Subject: RE: Albermarle Class 3 Landfill - (0175-S) 2025 AEIR

RE: Revised Pages - 2025 Annual Engineering Inspection Report
Albemarle South Plant, South Plant Landfill
Permit No. 0175-S
AFIN: 14-00028

ALBEMARLE SOUTH PLAN
MAGNOLIA, ARKANSAS
2025 ANNUAL ENGINEERING INSPECTION REPORT

BENCHMARK COORDINATE TABLE

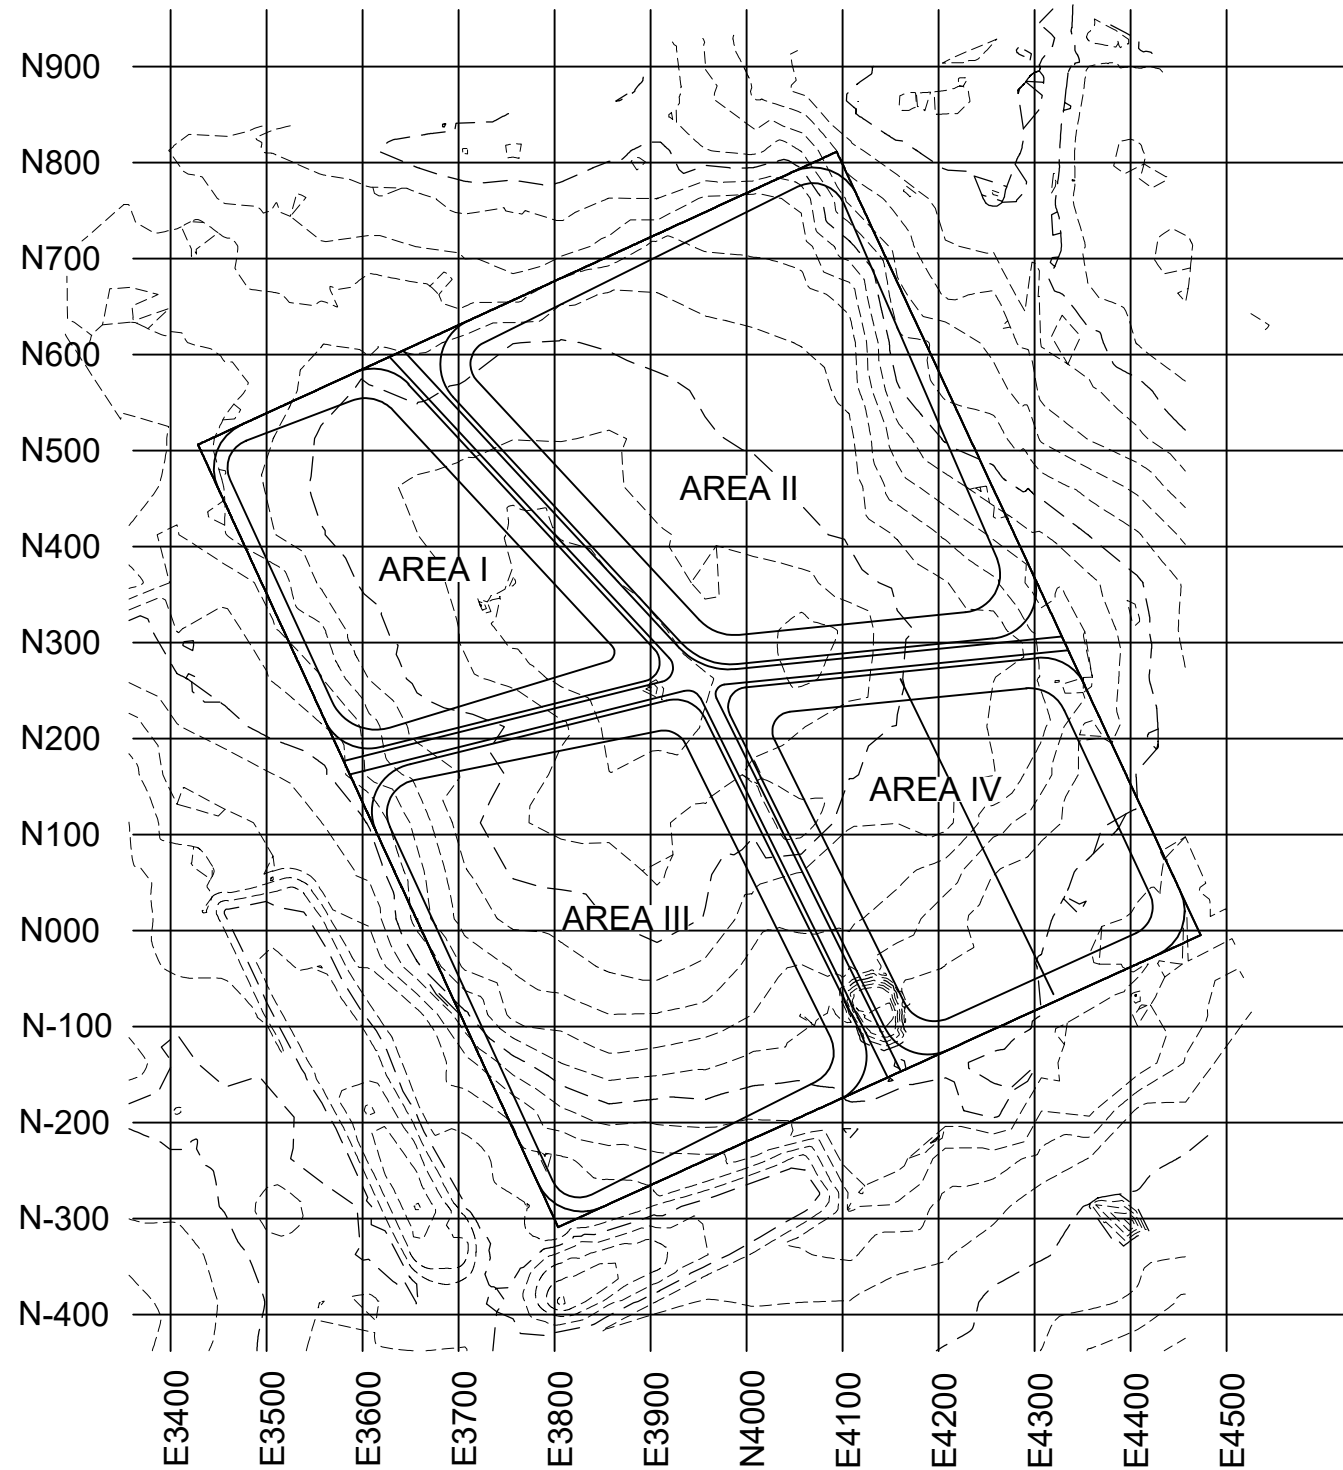
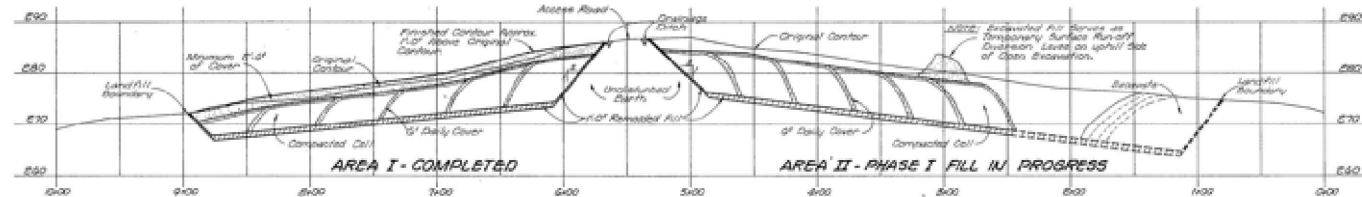
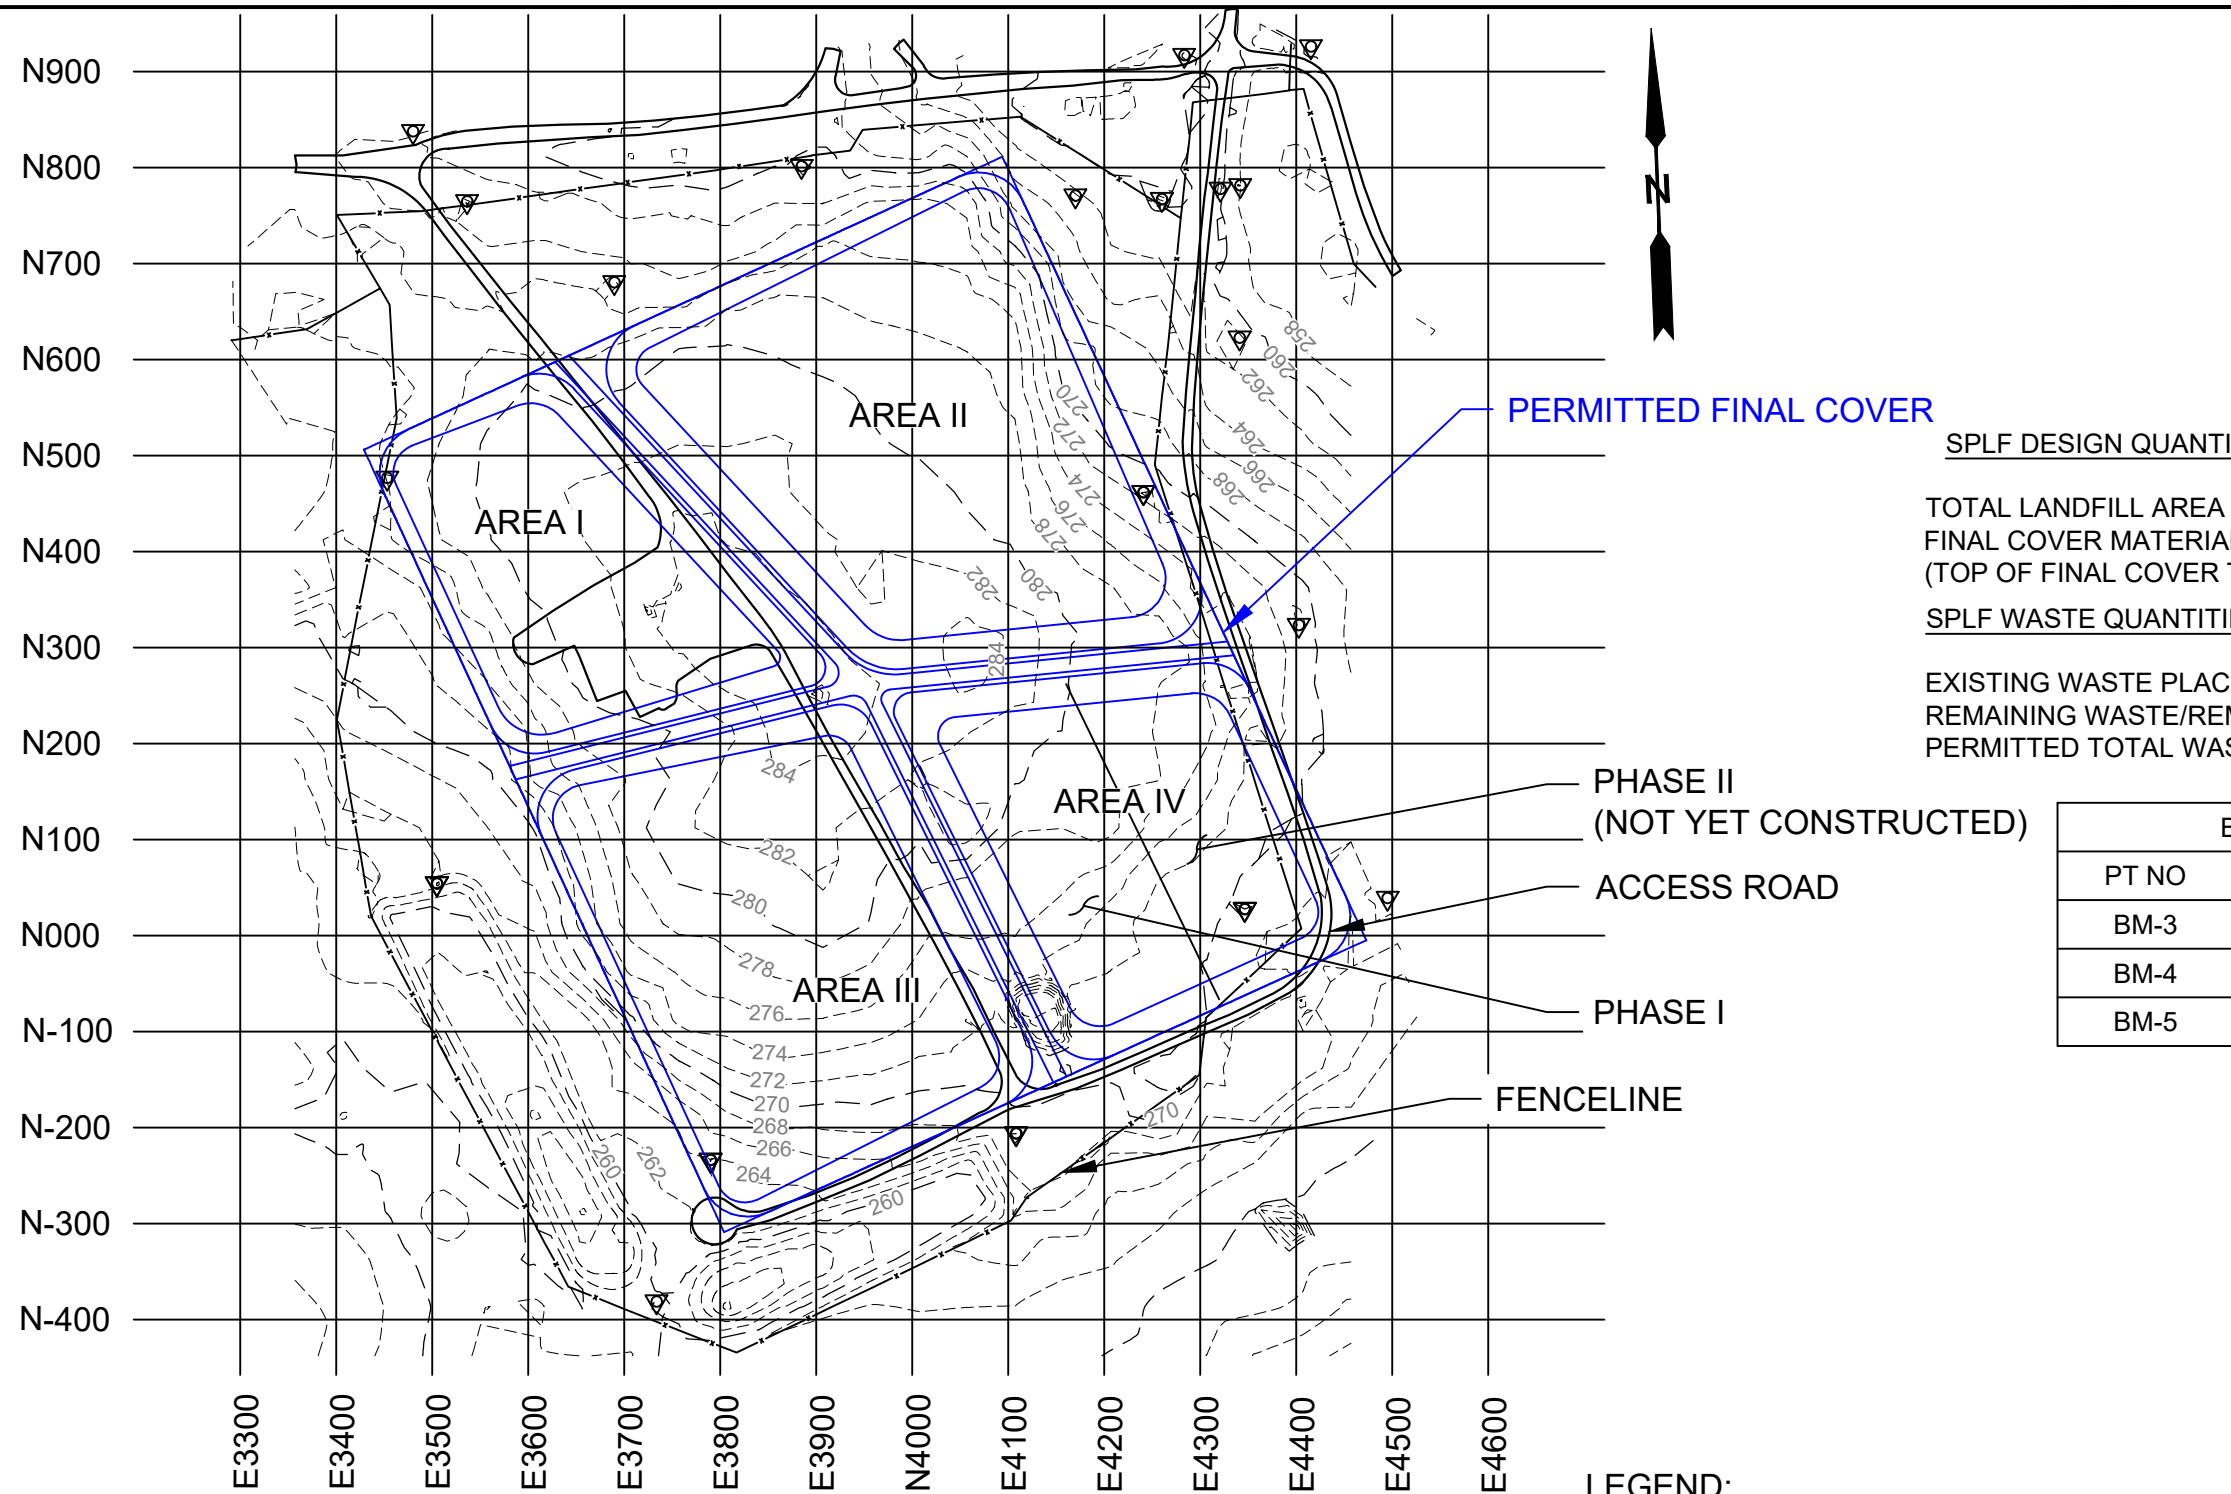
- 1) Survey benchmarks
- 2) New closure and Post-closure

PT NO	NORTHING	EASTING	ELEVATION
BM-3	1498155.12	942300.14	255.24
BM-4	1498155.21	942305.44	255.20
BM-5	1498583.78	940882.83	278.69
